## BRADFIELD HALL G12 GROWTH CHAMBER INSTALLATION

## **ADDENDUM NO. 1**

January 12, 2024

P-100R PARTIAL FLOOR PLANS - PLUMBING

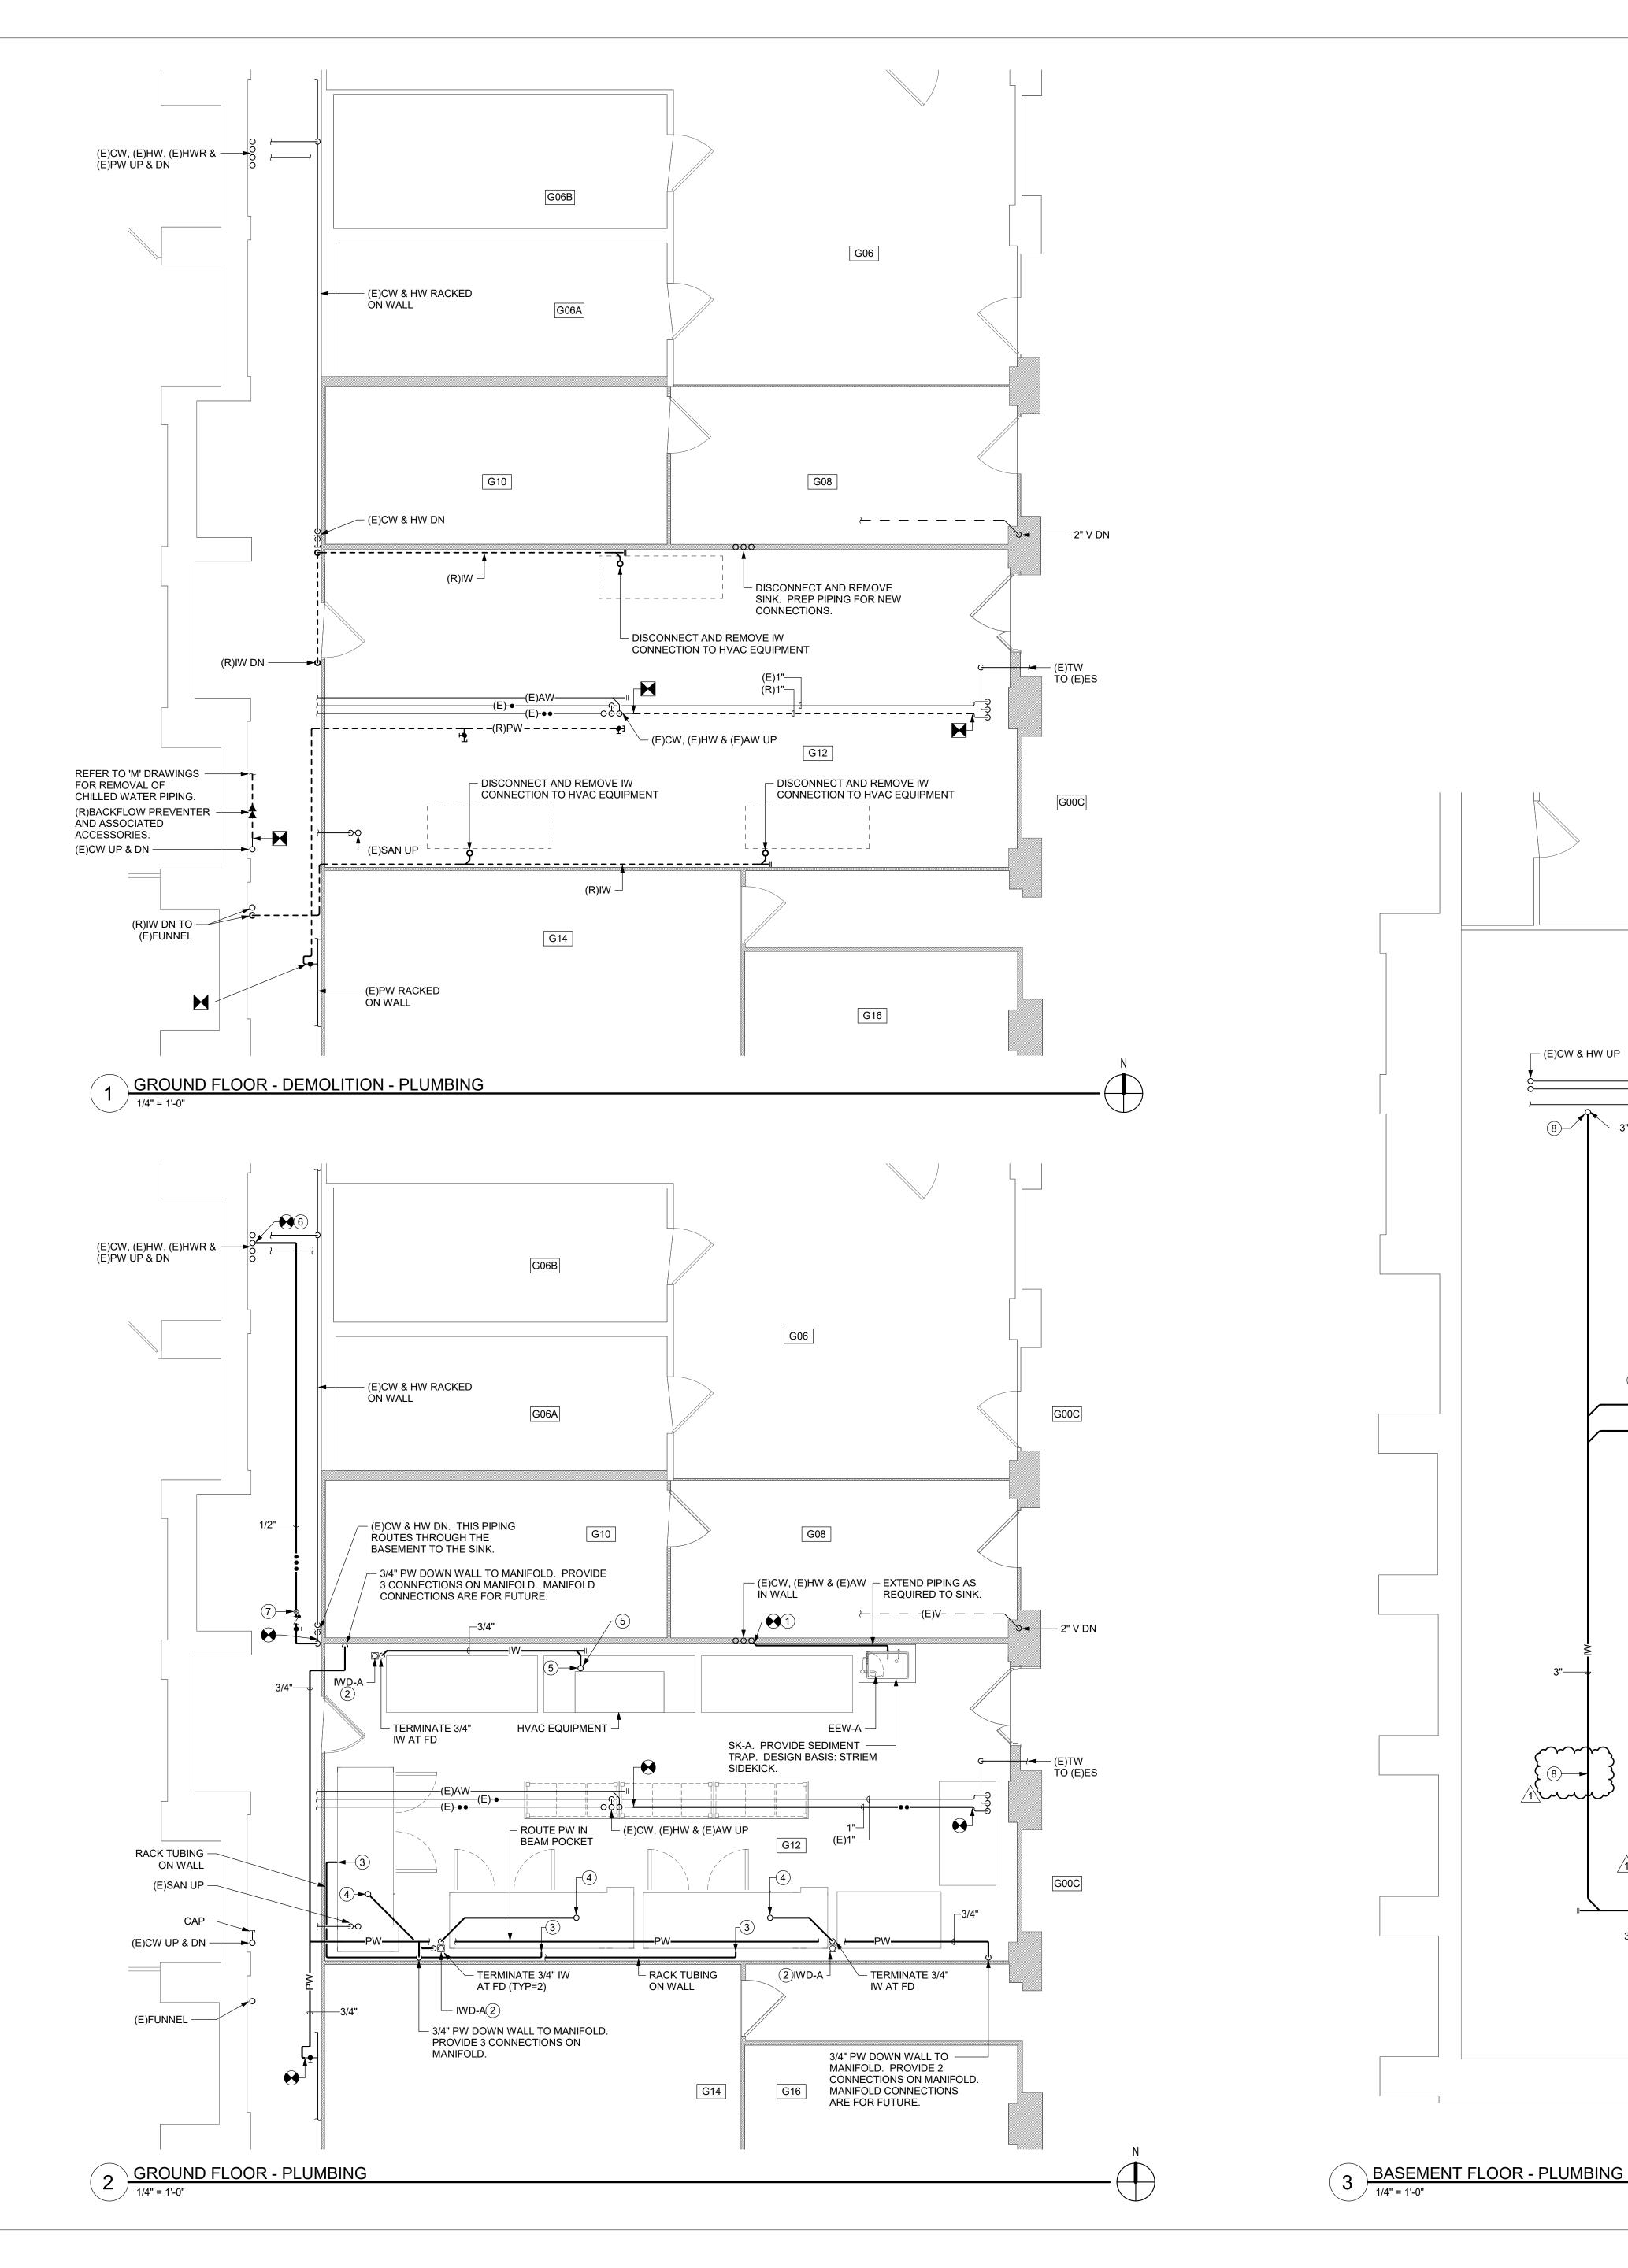
Item 1. Drawing P-100

**DELETE** in its entirety.

**REPLACE** with revised Drawing P-100R, attached.

WORK IN MECHANICAL SPACE: THIS IS A TWO-STORY SPACE WITH LIMITED AVAILABLE SPACE AND CONGESTED WITH DUCTWORK AND PIPING. WORK WILL BE HIGH IN THE SPACE AND REQUIRE TIES OFF AND RELATED OSHA REQUIREMENTS. BIDDERS TO VERIFY IN FIELD CONDITIONS AND ROUTING PRIOR TO BIDDING.
